City of Kingston
Planning Committee
Agenda

1. Recommendation Report: 5 Lower Union Street

**City of Kingston
Report to Planning Committee
Report Number PC-25-009**

**Re: Application for Zoning Bylaw and Official Plan Amendments
5 Lower Union Street, Kingston, ON
File Number D09-003-2021**

Figure 3 Possible configuration of mooring and breasting dolphins

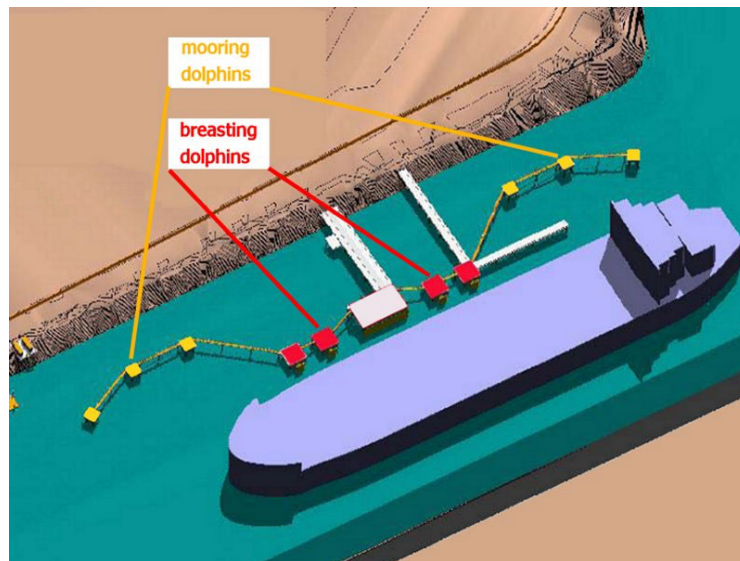
If the initial Waterfront path construction at the end of the 5 Lower Unit wharf is does not have the required structural strength for the later installation of breasting bollards, then a set of breasting docking dolphins will be needed as well as such the mooring dolphins. An example is shown schematically in Figure 3.

Figure 4 – Bus Parking in Turn-around Circle

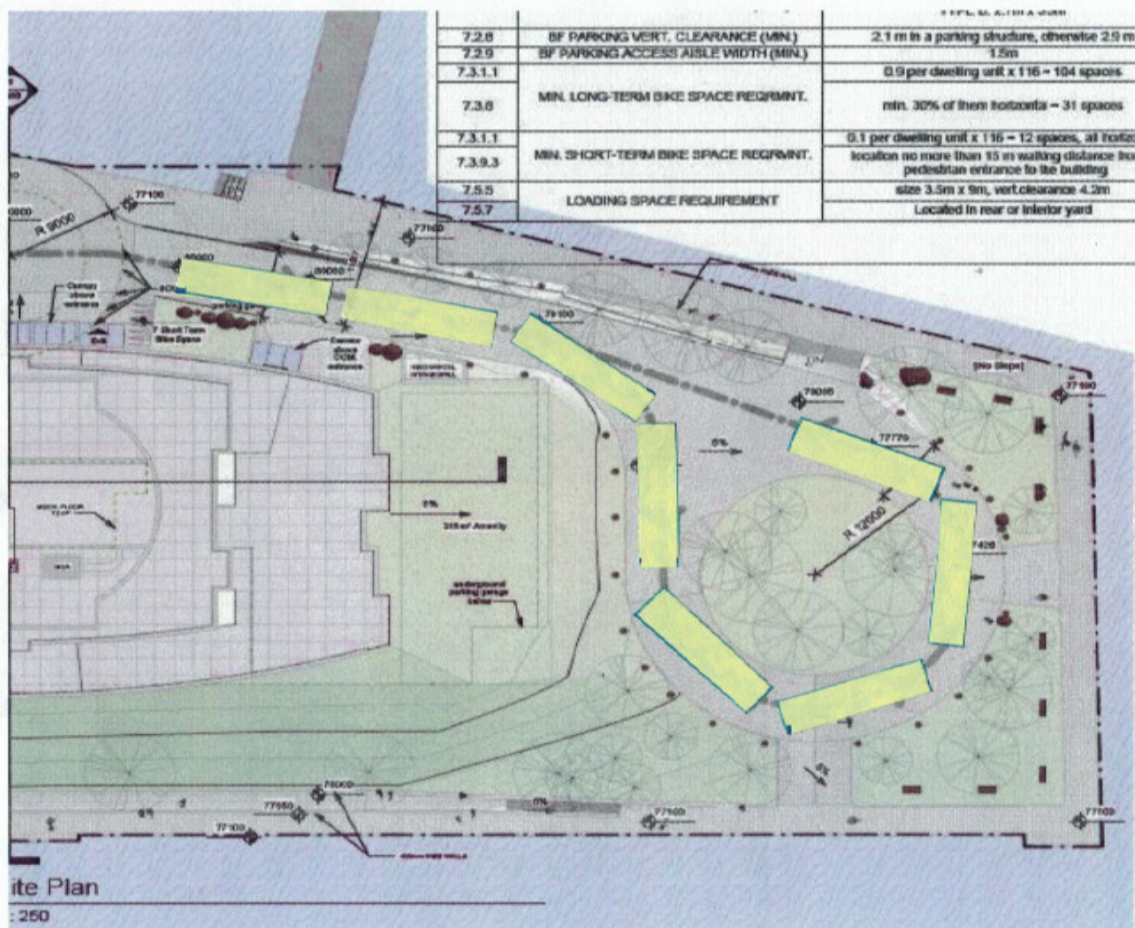
The dimensions of the Scania K114EBX2 bus are used as being typical of a 50-seat bus .The dimensions are listed in Table 2 and used in Figure 4. These buses are shown as yellow rectangles and are dimensioned to the same scale as the drawing. Figure 4 shows the worst-case scenario of the location of the buses to transport the 400 passengers disembarking to be taken to a scheduled event or events. Sufficient school buses (8) of 50 seat capacity are shown in the turnaround circle. They block the turn-around circle and could block the entrance traffic circle to the building garage with a long tail-back. Even a single bus could block the turn-around circle to other traffic and cause prolonged disruption to traffic and parking.

Furthermore, the ship turnaround circle is also the fire emergency access. This situation is not compatible with the need for immediate and urgent access by ambulances or fire tenders.

original drawing by Alexander Wilson Architect Inc.

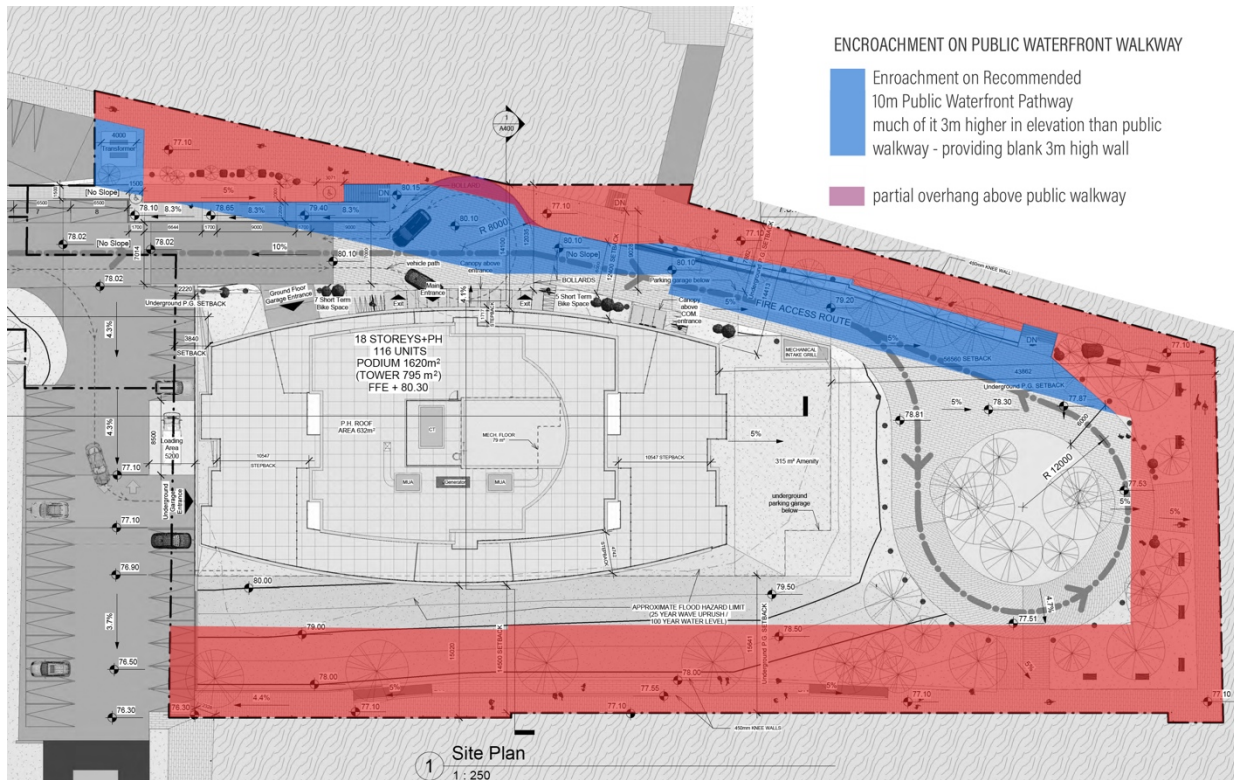
The drawing below is highlighted to illustrate the required 10m public zone (red + blue). It also illustrates the extent to which the current design proposal imposes upon that essential public space (blue). Most of this impact results from the proposed single storey structure created to provide vehicle access to a level one full storey above current grade, and above the proposed public walkway grade (more on the impact of this below under the heading View Corridor Encroachment). Also impactful is the retaining wall structures required to bring the large vehicle turning circle back down to adjacent grades. A pad-mounted transformer is also proposed to be within this Public Waterfront Walkway.

original drawing by Alexander Wilson Architect Inc.

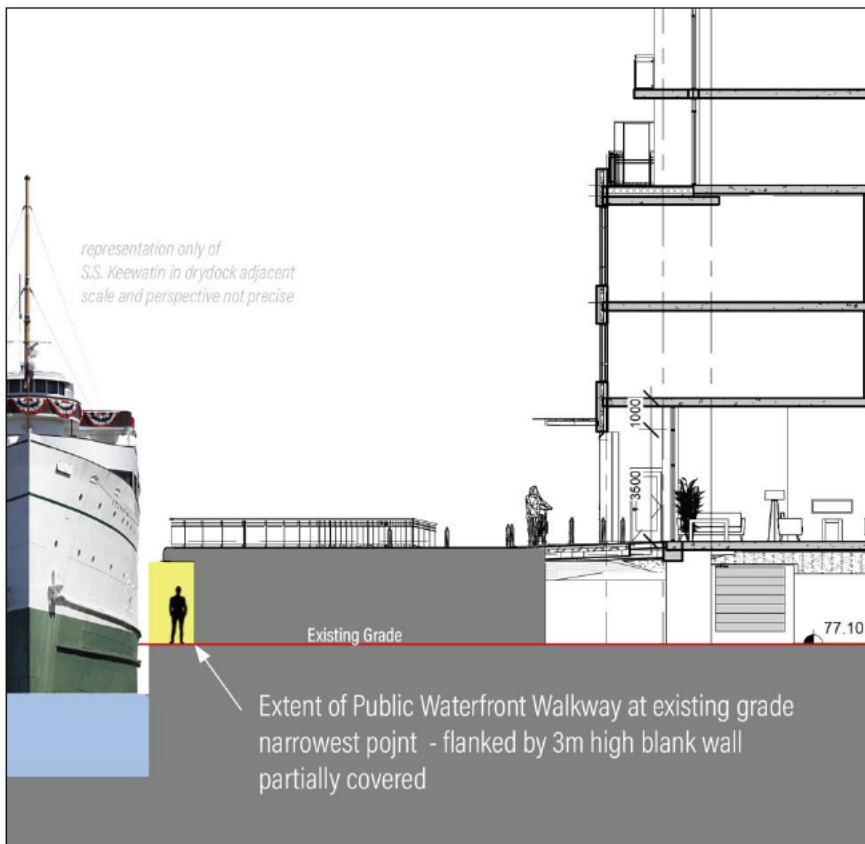
The most egregious imposition on the public walkway is proposed adjacent to the elevated drive lane/turning circle where the path is reduced in width to approximately two metres (not dimensioned). This restricted path is flanked by a blank wall nearly 3m high and partially covered by a cantilevered structure above it which would support the vehicle turning circle. This entirely inappropriate public space is made more cavernous by the adjacent Keewatin Cruise ship which is not illustrated on the drawings. The drawings also do not illustrate any detail regarding the walls of the drydock or the bollards with which the ship is moored. There may be conflicts to further reduce the available public walkway which are not yet apparent.

33. View analysis showing the protected view down Lower Union Street, to Lake Ontario, from Wellington Street, with the proposed tower (Source: Alexander Wilson Architect Inc, 2023).

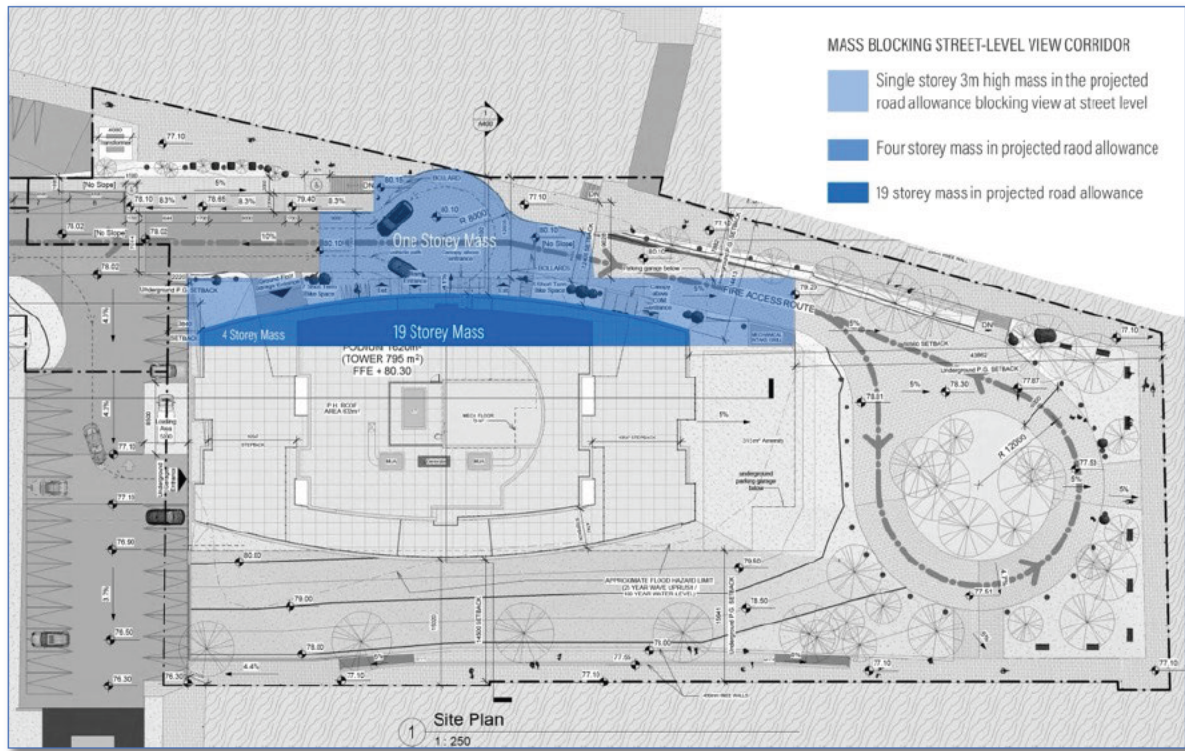
The following image is copied from the Urban Design Study and Conceptual Site Plan, March 1, 2023, by ERA Architects Inc. I believe that this image does not fully reflect the current design.

Proposed north elevation (Alexander Wilson Architects, 2023).

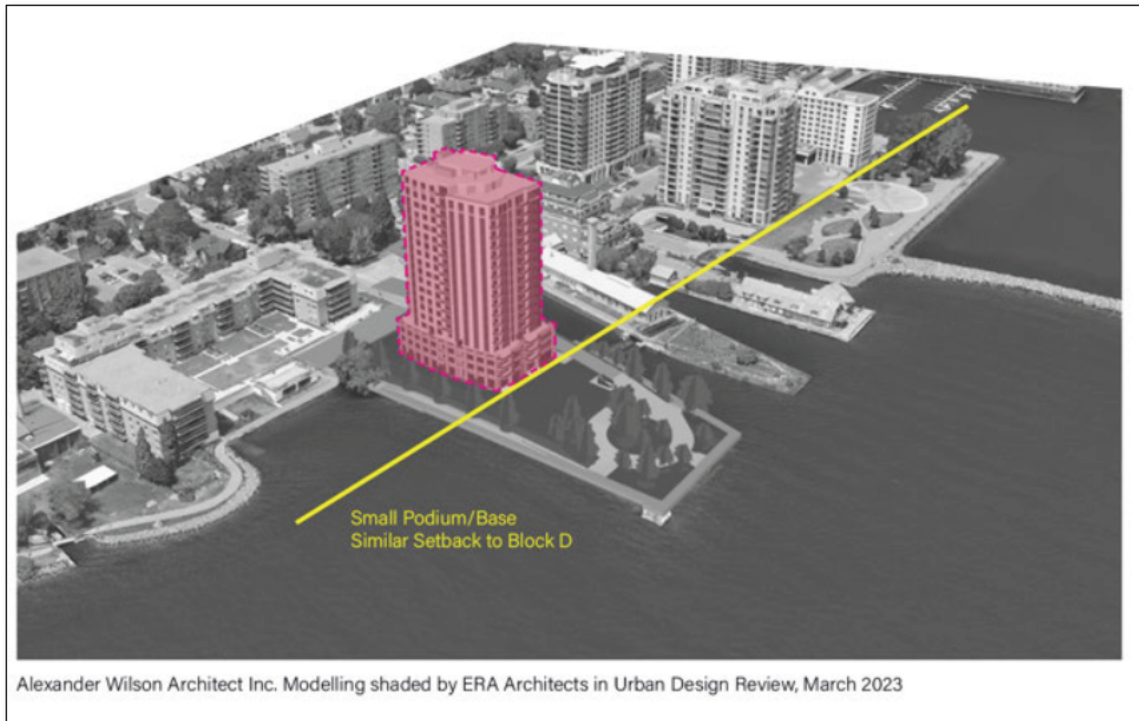
A pedestrian following the waterfront trail through Navy Park would be confronted by a long 4-storey high, imposing wall, with tower above. It is this pedestrian experience and the integration of the built form with the public realm which should be the focus of this design and not the abstract application of urban street design principles which are not suited to this location.

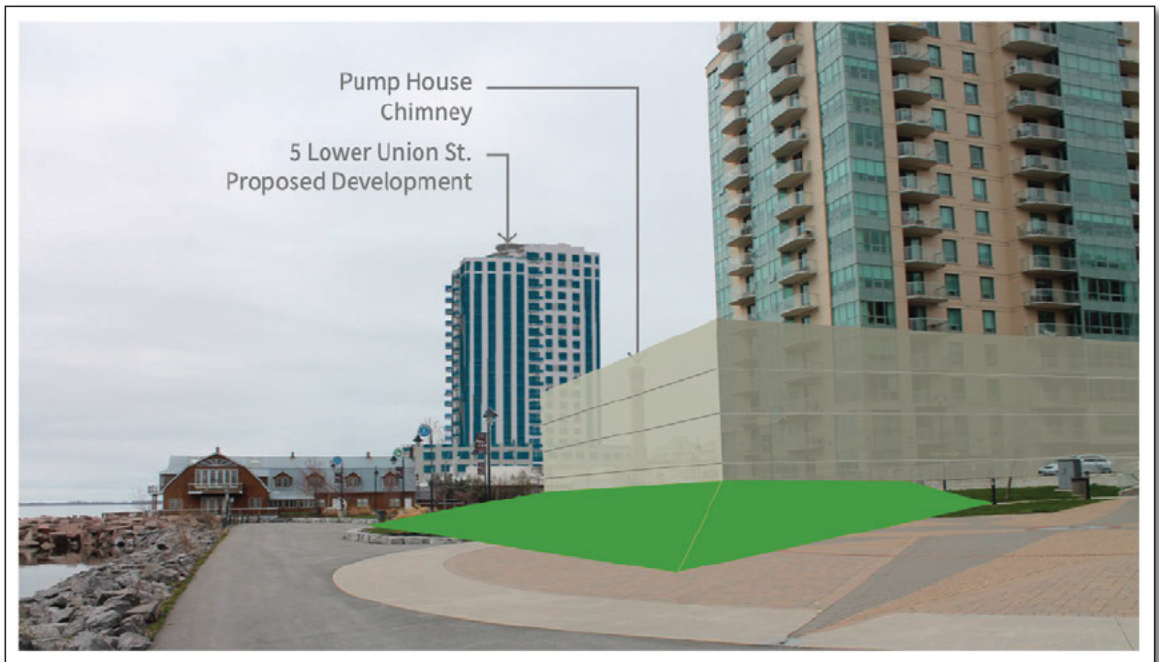
This image below from the latest ERA Architects' report shows the impact of the enlarged 4 storey mass, in contrast to the simple tower structure which is the Royal George Condominium on Block D.

The base of the proposed building would form a complete backdrop to the smaller scale heritage buildings on the waterfront trail. Let's imagine that the Royal George Condominium had adopted a similar form to that proposed for this new development as approximated below. This would be significantly more visually imposing than the building which exists, if it were just more private condos. It illustrates the inappropriateness of the proposed form, in this location. Imagine the impact if this design principle had been applied to all four buildings on Block D.

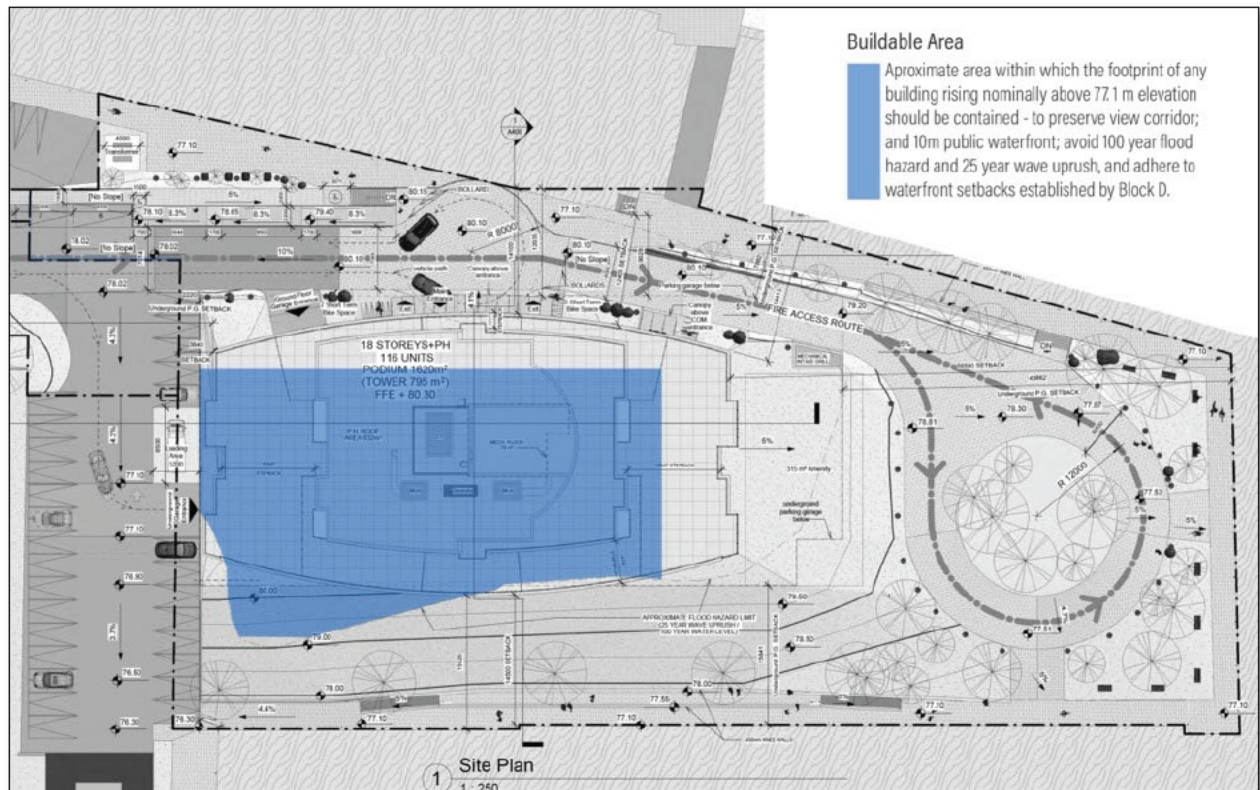
The City of Kingston “Density by Design: Kingston Mid-Rise and Tall Building Policy - Issues and Options Report” page 28, recommended a maximum 700m2 floor plate for waterfront buildings. The current design is 795m2.

1. a footprint within the buildable area defined by the figure above, respectful of view corridor, public walkway space, environmental hazards and precedent set-backs (Block D),
2. a tower with a floor plate of 700m² or less,
3. a building height less than 17 stories,
4. a “shallow” rather than “deep” floor plate design,
5. a building design which minimizes impact on vistas over the water,
6. base level finishes, textures and quality of materials which reflect the heritage architecture in the vicinity of the project, and
7. excellence in architecture and landscape design which better integrates the building form with the public realm.
